# UNITED STATES PATENT AND TRADEMARK OFFICE

| APPLICATION NO. | FILING DATE | FIRST NAMED INVENTOR | ATTORNEY DOCKET NO. | CONFIRMATION NO. |
|-----------------|-------------|----------------------|---------------------|------------------|
| 09/542,783      | 04/04/2000  | John Whitman         | 4294US(98-1208)     | 6870             |

| <b>Office Action Summary</b> | <b>Application No.</b><br>09/542,783 | <b>Applicant(s)</b><br>WHITMAN ET AL. |  |

## DETAILED ACTION

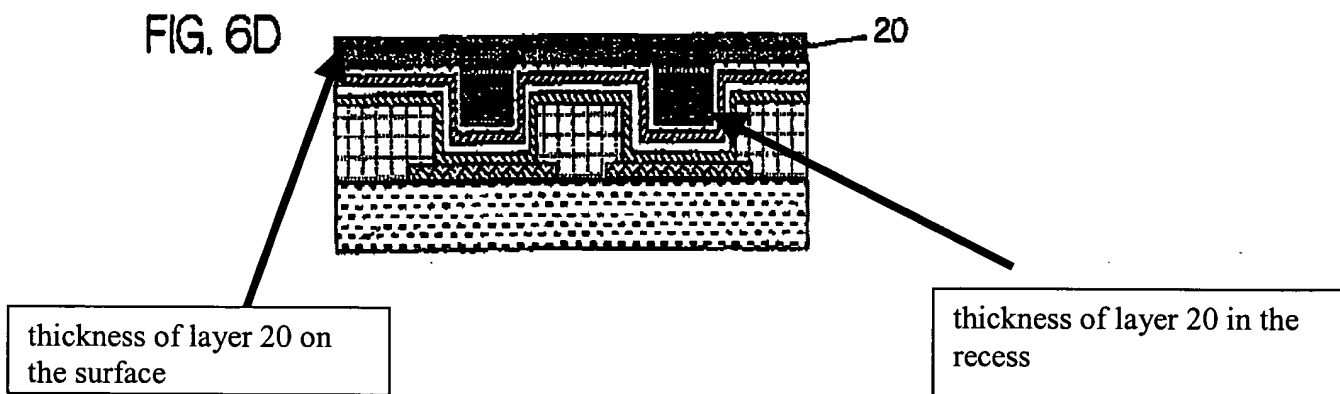
For example, as depicted in Fig. 6D below, Kikuchi et al. '153 clearly show the thickness

of layer 20 at the surface is lower than that of in the recess. Since there is no quantitative dimensional range in the rejected claims, appellants' argument that "Kikuchi et al. '153 drawings are not to scale" has no merit.

In addition, Fig. 6D shows a planar surface of the resist layer 20 on the surface which substantially fill the recess 23a. Kikuchi et al. '153 also disclose in the specification spin-coating process, i.e., a well-known process to one having ordinary skill in the art to deposit resist layer and to planarize the layer, which by the way same process is used in the instant application for the purpose of achieving planar surface. The following disclosed by Kikuchi et al. '153: "as illustrated in FIG. 6D, resist 20 is deposited over the third electrically conductive thin layer 27. If the resist 20 composed of liquid material, the liquid material is deposited on the third electrically conductive layer 27 by spin-coating, die-coating, curtain-coating or printing (see . Kikuchi et al. '153 Col. 17, lines 62-66). The purpose of spin-coating during

deposition of the resist layer, as well-known to one of ordinary skill in the art, is to form a resist layer having a planar surface. As the term implies, spin coating removes excess material as result of spinning of the wafer during coating operation. Therefore, Kikuchi et al. '153 as shown in Fig. 6D explicitly or implicitly teach depositing of a material 20 having planar surface on a surface.

**Fig. 2**

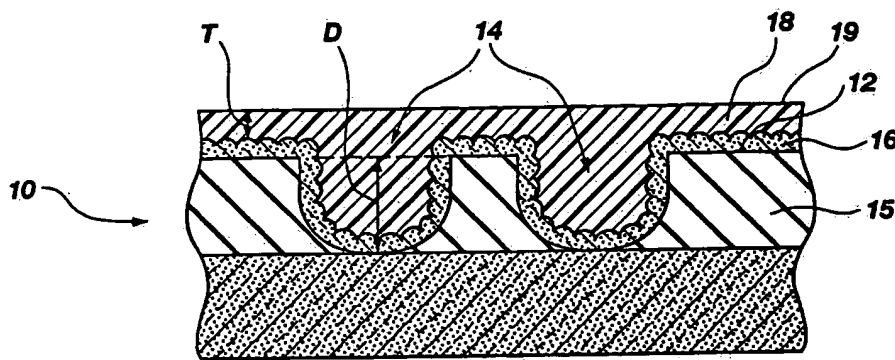
In light of the supporting disclosure, claim 2 is interpreted in view of Figs. 2 and 3 of the instant application. For illustrative purpose, Figs. 2 and 3 are reproduced below.

As depicted in Fig. 2 above, the material layer 18 is disposed over a surface 12 to substantially fill the recess (container) 14 (see the instant application specification in Page 12, paragraph 0038). As recited in claim 2, “wherein said disposing comprises disposing said material so as substantially fill said at least one recess without substantially without substantially covering said surface” is interpreted in conjunction with Fig. 3. After the material layer 18 (i.e., the resist layer) deposited to fill the recess 14 and cover the surface 12 as shown in Fig. 2 above, the material layer 18 (i.e., the resist layer) is removed from the surface (i.e., *disposing* a material on

**Fig. 3**

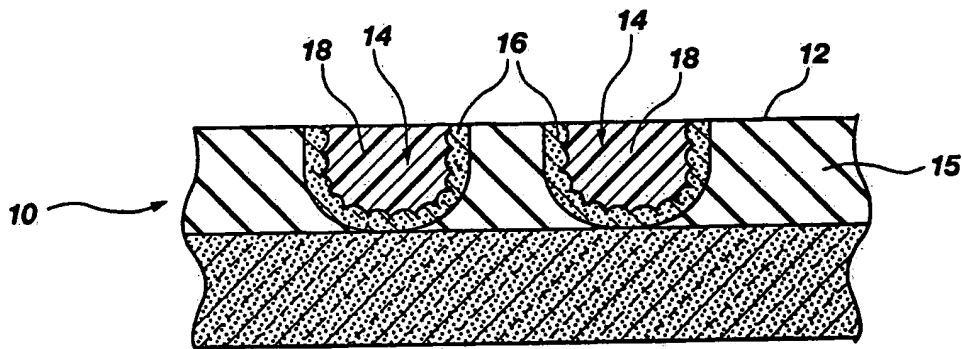
a surface of a semiconductor device structure and within recesses thereof so as to substantially fill the recesses *without substantially covering the surface* ) during subsequent process as shown in Fig. 3 below (see also the instant application specification page 14, paragraph 0041).

In addition, there is no selective deposition process disclosed in appellants' disclosure or in the rejected claims that would lead one of ordinary skill in the art to a different interpretation.

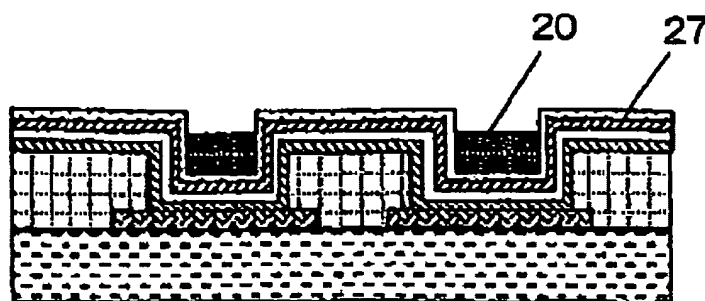
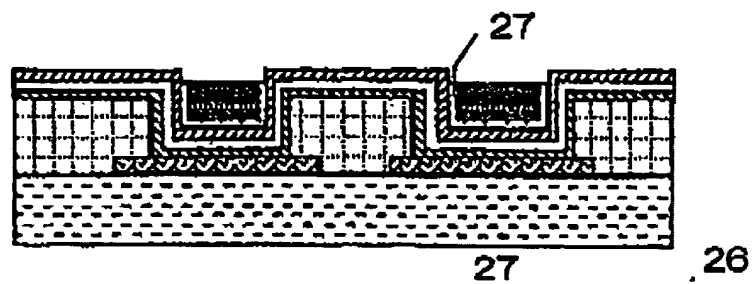
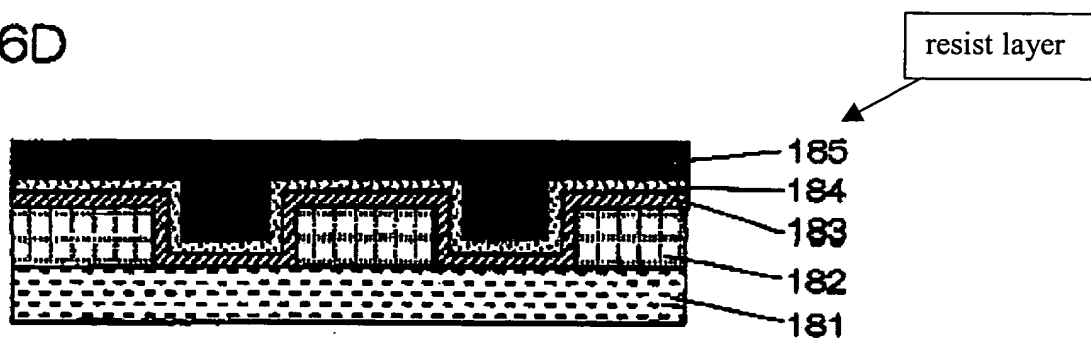
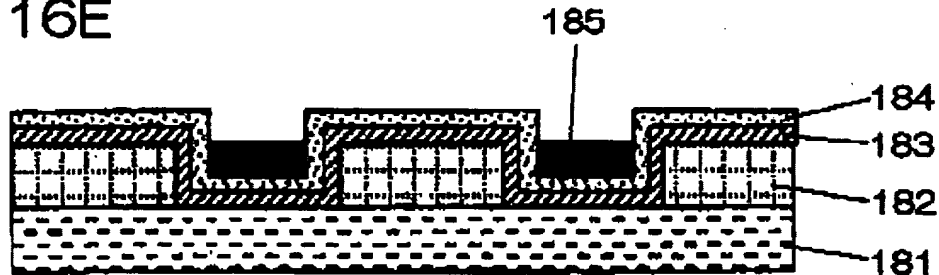
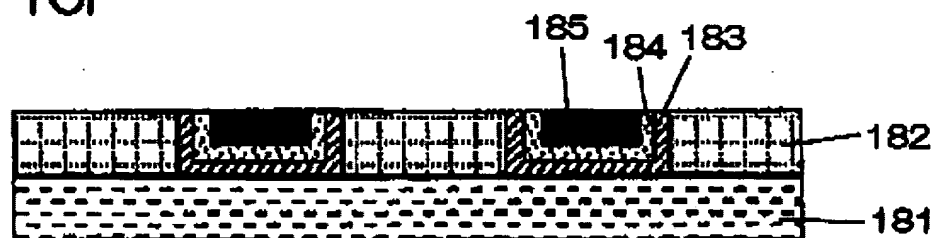
Similarly, Kikuchi et al. '153 disclosure, as depicted in Figs. 6E and 6F or 16D-16F below, is consistent with claim 2 and Figs. 2 and 3 of the instant application.

Hence, applicants' contention that "Kikuchi neither expressly nor inherently describes disposing a material on a surface of a semiconductor device structure and within recesses thereof so as to substantially fill the recesses without substantially covering the surface..." has no merit because the rejected claim is consistent with Kikuchi et al. '153 disclosure.
